**NOTICE OF MEETING**
**CITY COUNCIL OF THE CITY OF GALVESTON**
**THURSDAY - FEBRUARY 27, 2020 - 1:15 P.M.**
**COUNCIL CHAMBERS - CITY HALL**
**823 ROSENBERG, GALVESTON, TEXAS**
**TELEPHONE: (409) 797-3510**

8.A. Consider For Approval An Ordinance Of The City Of Galveston, Texas, Creating A Planned Unit Development (PUD) Overlay Zoning District In A Commercial, (C) Base Zoning District With A Height And Density Development Zone, Zone-6 (C-HDDZ-6) Overlay Zoning District To Allow A Ten-Story Apartment Development To Be Constructed On The Property Commonly Known As 12212 San Luis Pass Road And Which Is Legally Described As The West 311.7 Feet Of Lot 1, Resort Subdivision, In The City And County Of Galveston, Texas; Planning Case Number 20P-002; Making

**REQUEST:**
Planned Unit Development (PUD)

**EXHIBITS:**
A – Zoning Map
B – Narrative/ PUD Plan
C – Site Plan/PUD Plan

SD1.5
Elevations
01/024/2020

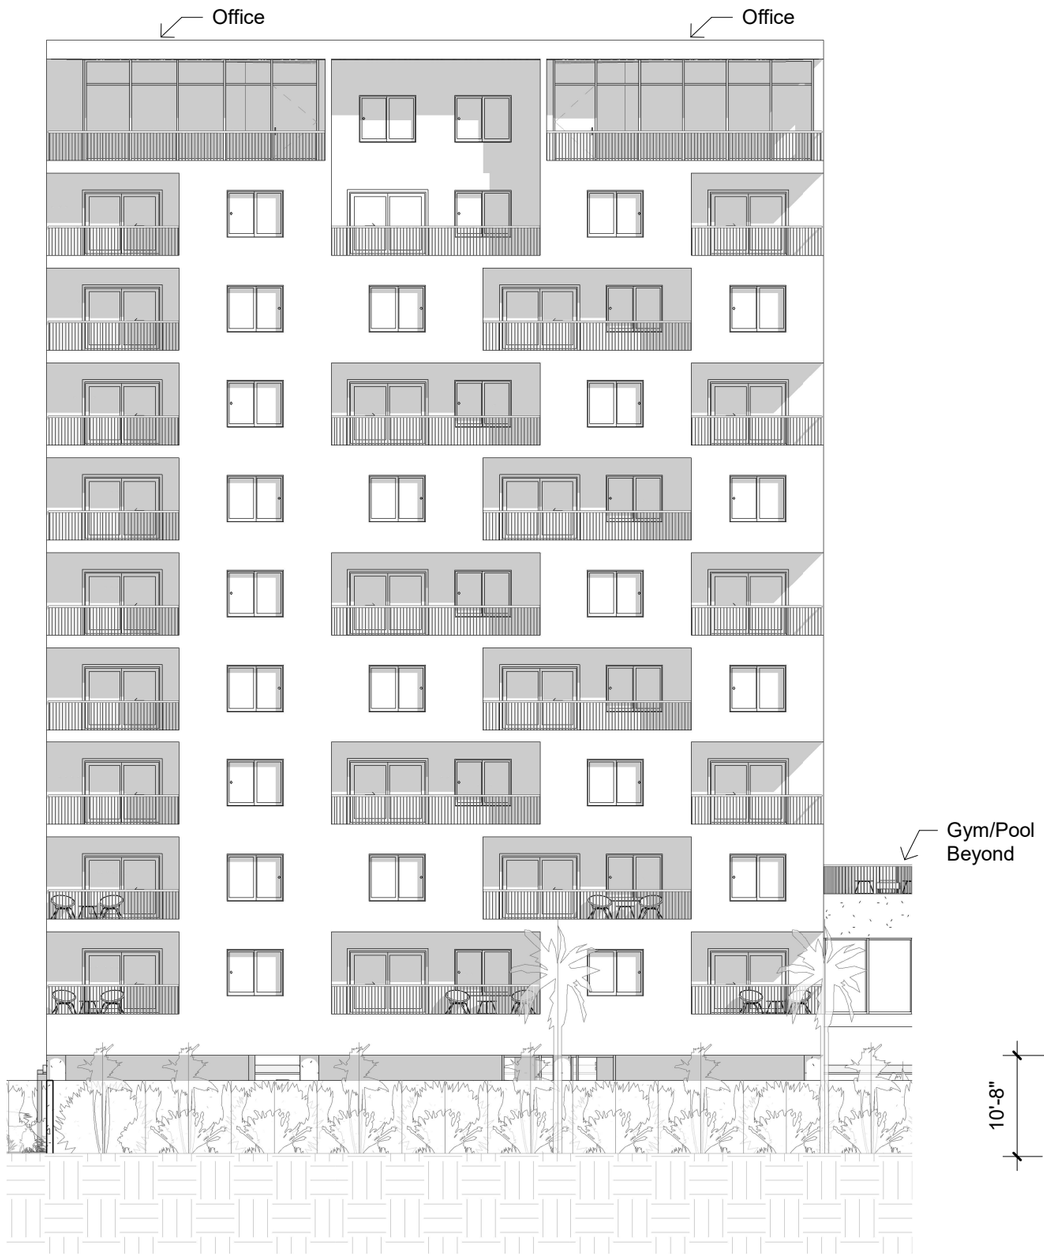
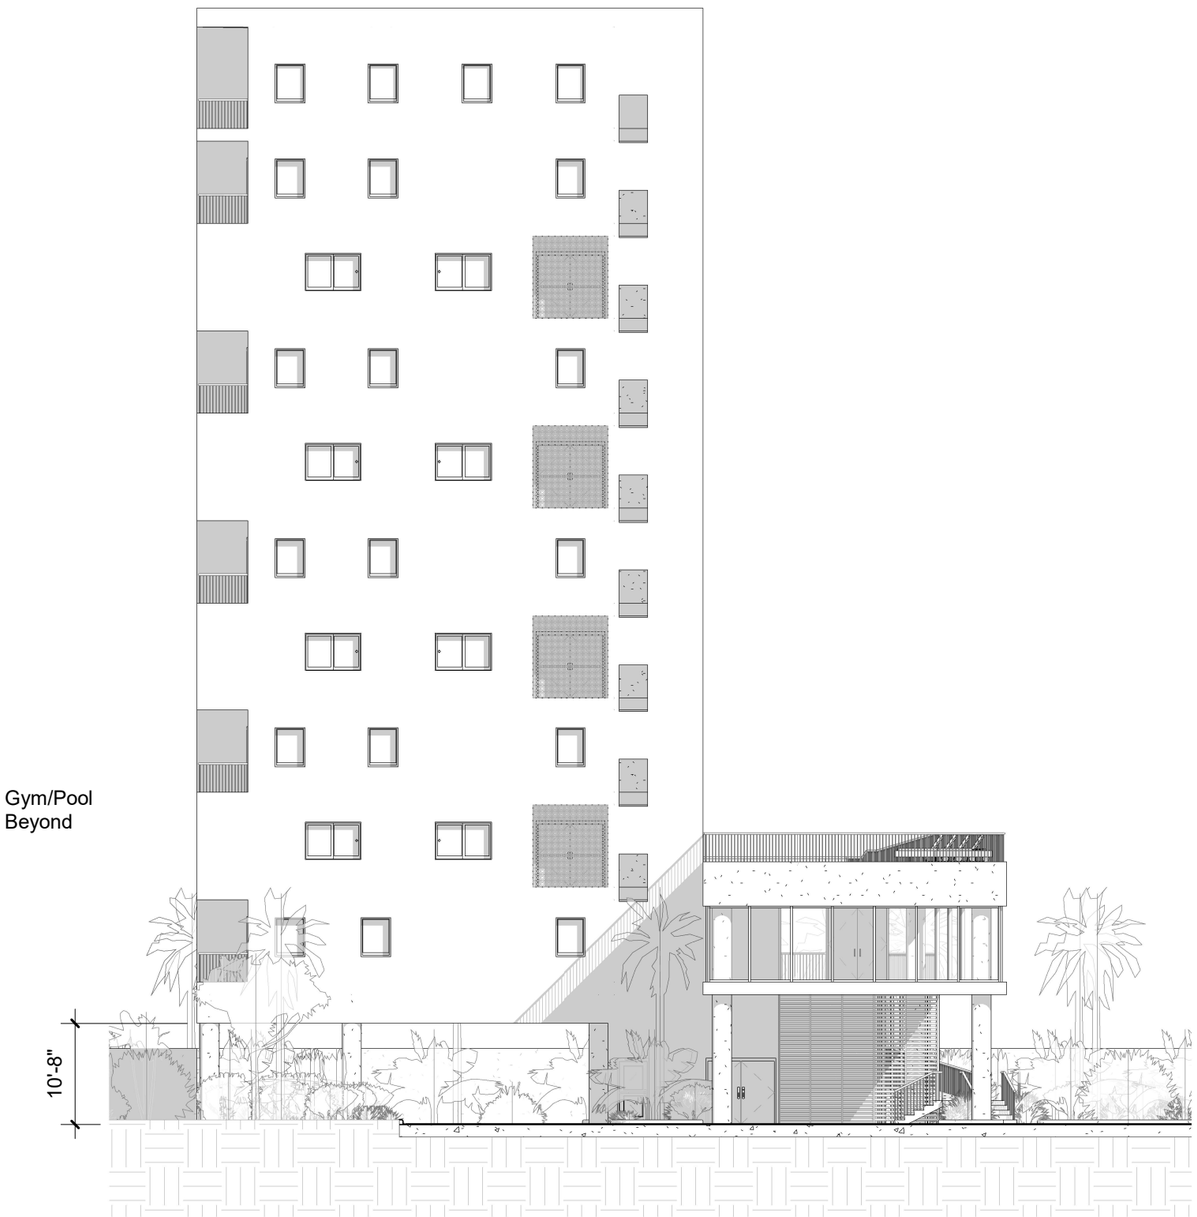
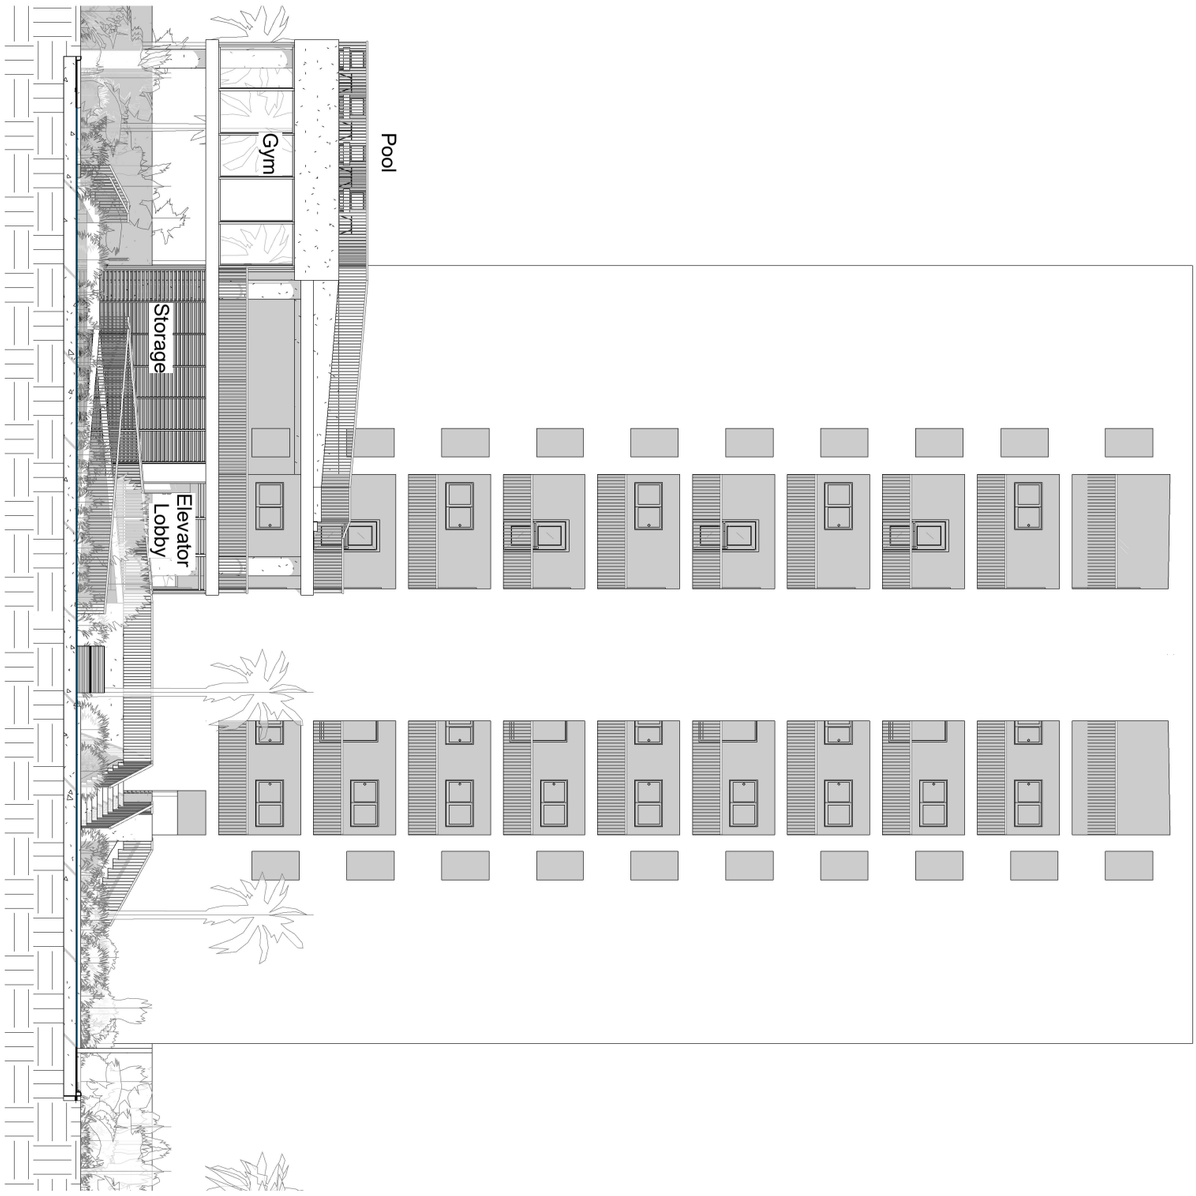
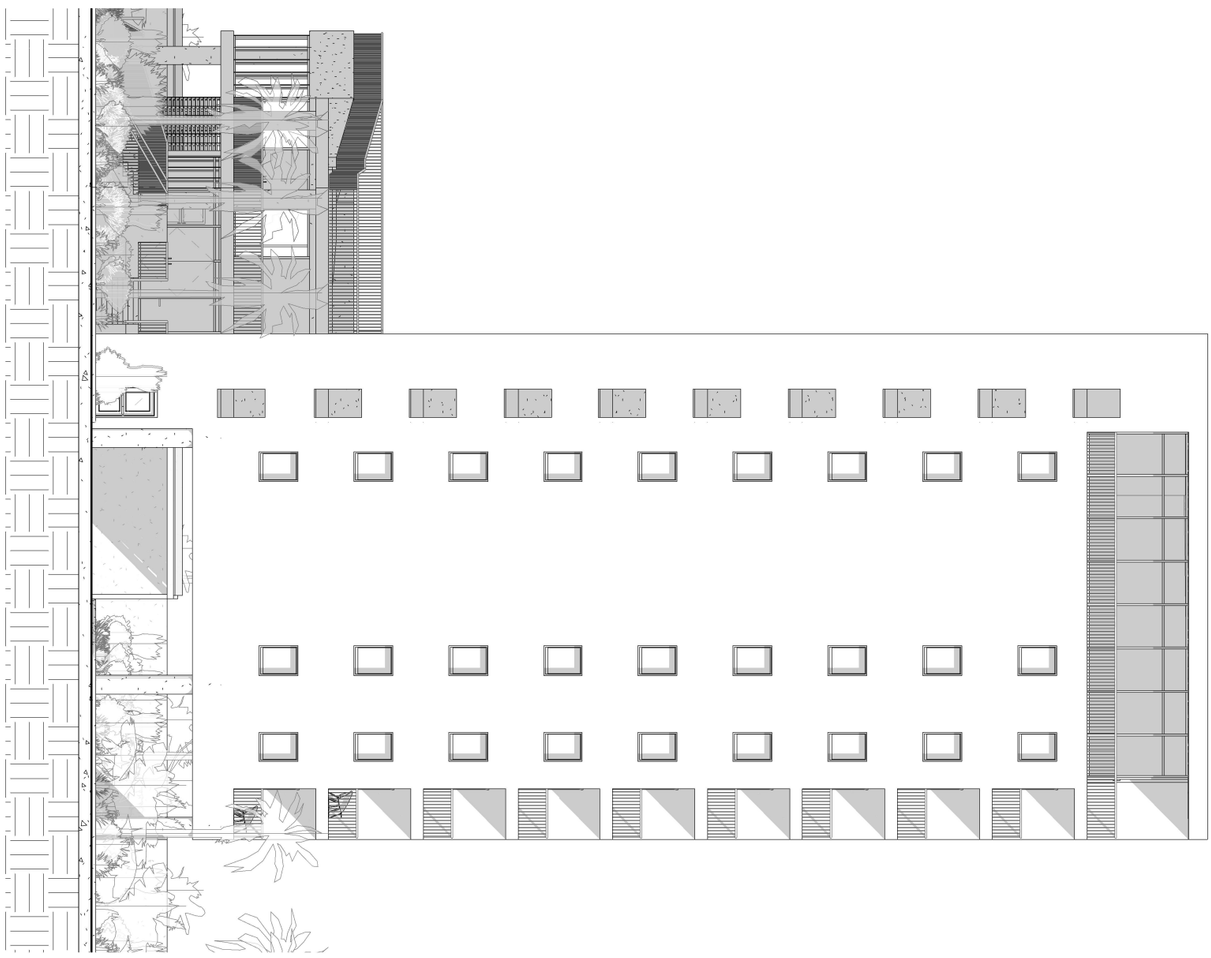
| **Building Elevations** | The applicant is deviating from wall plane articulation. The building elevations on the north and south show the structure with balconies and openings that do provide visual interest without traditional wall plane articulation.<br>The east and west sides have window openings and show a partial view of the balconies.<br>The structure is located in a VE (16) flood zone. The new development will meet all FEMA elevation requirements and City free board requirements. *Please reference SD 1.5 and SD 1.6 and* page *2, Exhibit: C – Narrative.* |
